Intersection ID: 46340	Main Street: KENNON_ST	Cross Street: UMSTEAD_ST	Location:	NE
ADA ID: DB053519B450	Ramp Type: ParaDiag	Initial Pass/Fail: Fail	Overall Compliance: No	Severity Score: 21.25

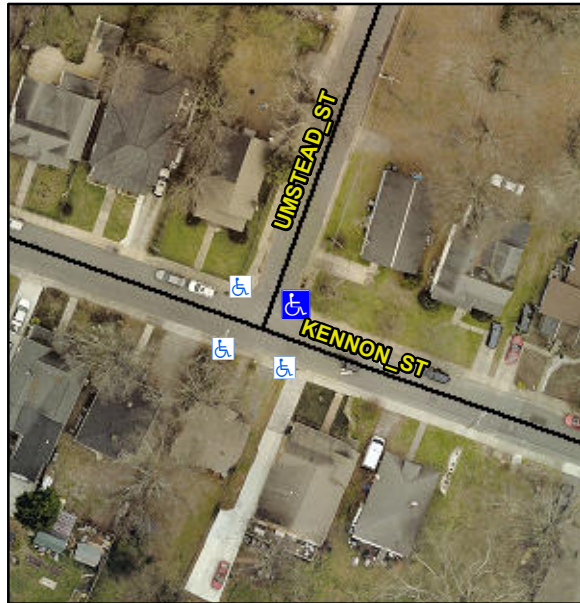
RT RP < 5%

R304.5.1, R304.5.3

Remove & Replace Curb Ramp With Two New Directional Ramps or Equivalent.
